# T ECHNICAL INFORMATION

66914  
(Page 1 of 2)

- Subject** ▶ Change of Name Plate, etc.
- For Models** ▶ 1911B, 1912B
- Country** ▶ All countries
- Description** ▶ 1) Current Name Plate and Scale Plate are riveted on Main Frame.  
New Name Plate and Scale Label adheres to Main Frame.  
2) Rubber Pins have been eliminated.

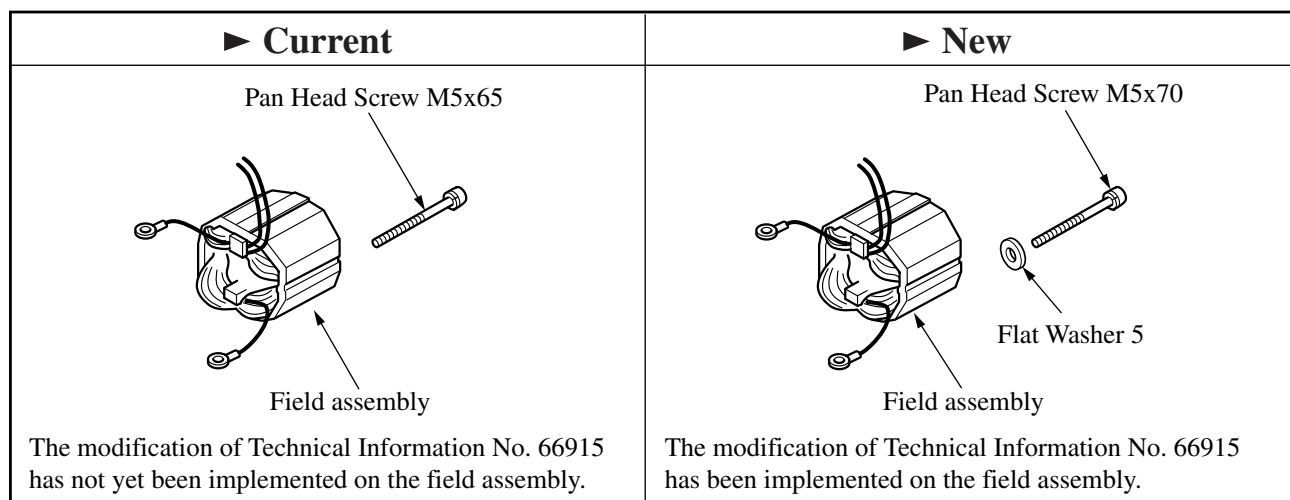
- 3) Pan Head Screw M5x65 has been replaced by Pan Head Screw M5x70.  
Flat Washer 5 has been added.

Item No.	Current part		Q'ty	I/C	New part		Q'ty	Note
019	Scale Plate 816406-0		1	←	Scale Label 816381-0		1	A constituent part of Main Frame Complete For 1911B
1911B: 019 1912B: 015	Scale Plate 816695-7		1	←	Scale Label 816382-8		1	A constituent part of Main Frame Complete For 1911B, 1912B
010	Name Plate 815099-0		1	←	Name Plate 853285-5		1	For 1911B
006	Name Plate 851926-7		1	←	Name Plate 853294-4		1	For 1912B

Item No.	Current part		Q'ty	I/C	New part		Q'ty	Note
1911B: 027 1912B: 023	Rubber Pin 4 263014-2		1					<div style="text-align: center;"> ↑  Constituent parts of  Main Frame complete  For 1911B, 1912B  ↓ </div>
1911B: 050 1912B: 047	Rubber Pin 4 263002-9		1					
1911B: 019 1912B: 015	Rivet 0-5 953106-2		4					
1911B: 011 1912B: 007	Rivet 0-5 953106-2		4					
1911B: 019 1912B: 015	Main Frame Complete 159689-2		1	Yes	Main Frame Complete 159689-2		1	For 1911B, 1912B
019	Main Frame Complete 159652-5		1	Yes	Main Frame Complete 159652-5		1	For 1911B
019	Main Frame Complete 159336-5		1	Yes	Main Frame Complete 159336-5		1	For 1911B
1911B: 031 1912B: 027	Pan Head Screw M5x65 911290-9		2	No	Pan Head Screw M5x70 911295-9		2	For 1911B, 1912B
1911B: 066 1912B: 052					Flat Washer 5 267012-8		2	For 1911B, 1912B
